AUBURN HILLS 13TH ADDITION

RE: S/D 00-10 -- Final Plat of AUBURN HILLS 13TH ADDITION

RE: S/D 00-10 -- Final Plat of AUBURN HILLS 13TH ADDITION

CASE NUMBER: S/D 00-10 -- AUBURN HILLS 13TH ADDITION

AUBURN HILLS 13TH ADDITION
WICHITA, SEDGWICK COUNTY, KANSAS

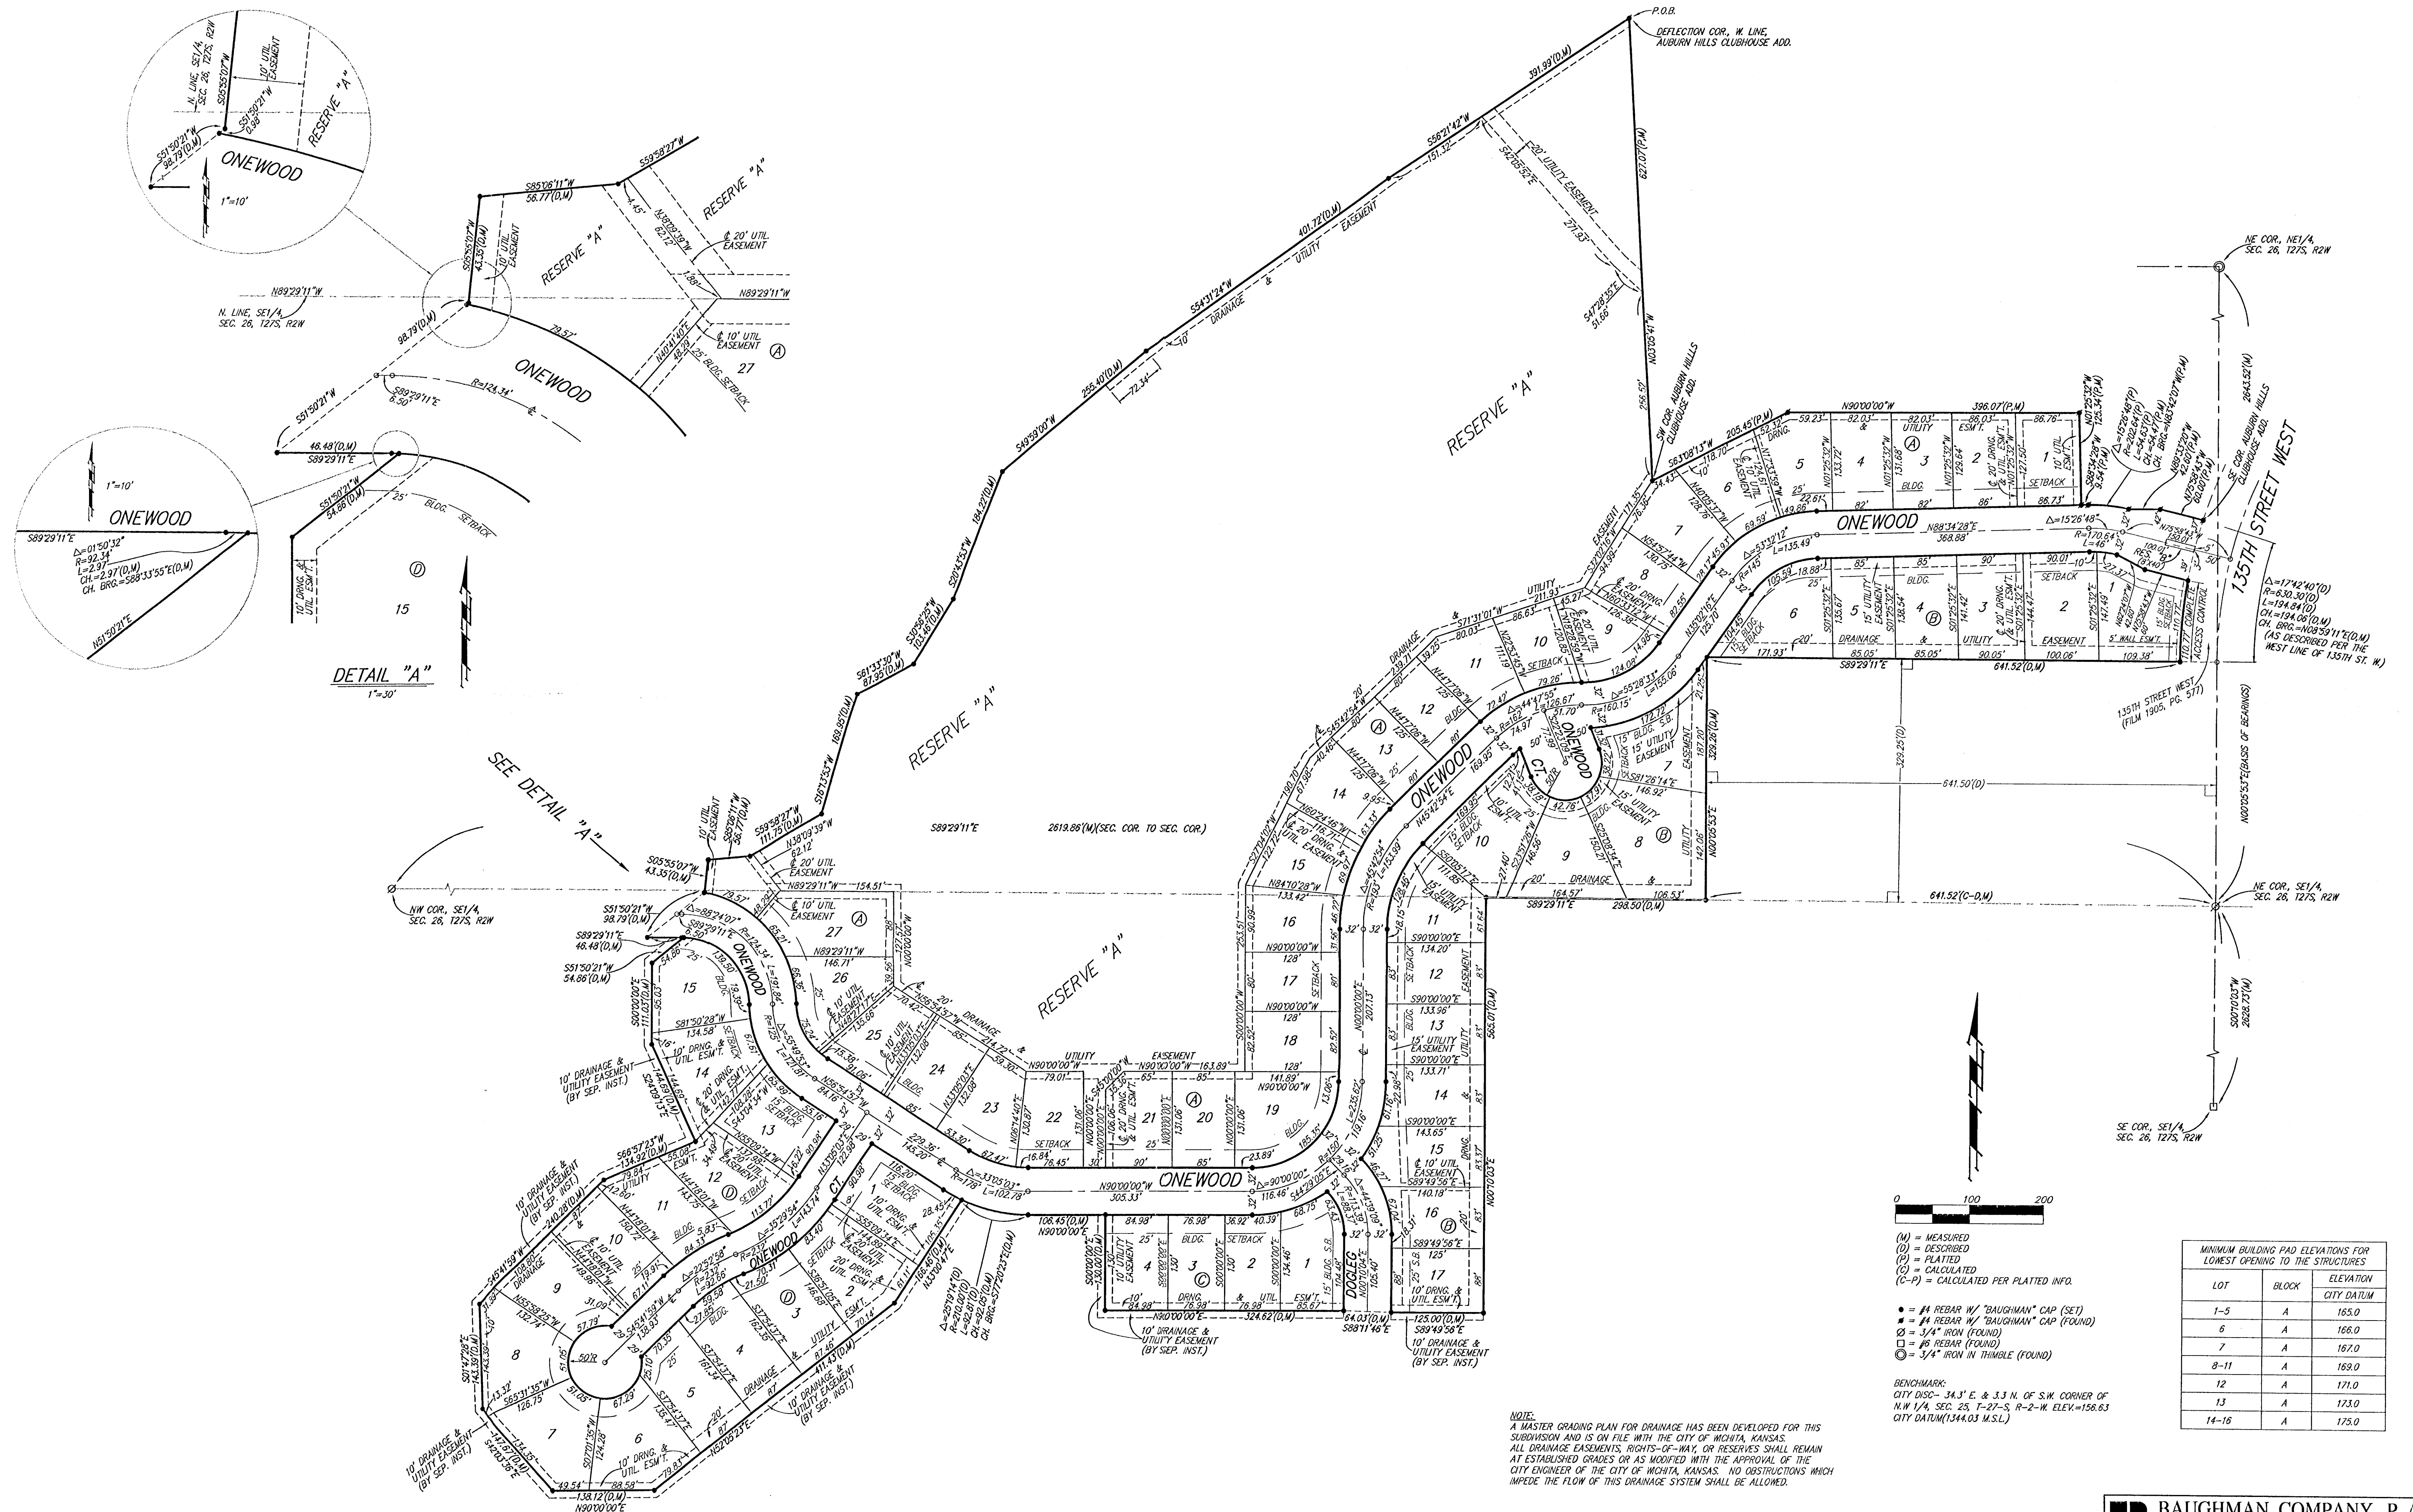
- D. If this site develops before Auburn Hills 12th, a temporary turnaround will need to be provided at the terminus of Onewood to the west and referenced in the plat's text on the final plat.

- I. A definite location needs to be denoted for the utility easement in the northeast portion of Reserve A.
- J. A definite location needs to be denoted for the utility easement northeast of Lot 27, Block A, in Reserve A.

- K. The centerline of Dogleg Street needs to be located at Onewood Street.
- L. Bearings needs to be added for the north line of Lot 1, Block B.
- M. The Applicant is reminded that a platting binder is required with the final plat. Approval of this plat will be subject to submittal of this binder and any relevant conditions found by such a review.

- D. If this site develops before Auburn Hills 12th, a temporary turnaround will need to be provided at the terminus of Onewood to the west and referenced in the plat's text on the final plat.

- I. A definite location needs to be denoted for the utility easement in the northeast portion of Reserve A.
- J. A definite location needs to be denoted for the utility easement northeast of Lot 27, Block A, in Reserve A.

- K. The centerline of Dogleg Street needs to be located at Onewood Street.
- L. Bearings needs to be added for the north line of Lot 1, Block B.
- M. The Applicant is reminded that a platting binder is required with the final plat. Approval of this plat will be subject to submittal of this binder and any relevant conditions found by such a review.
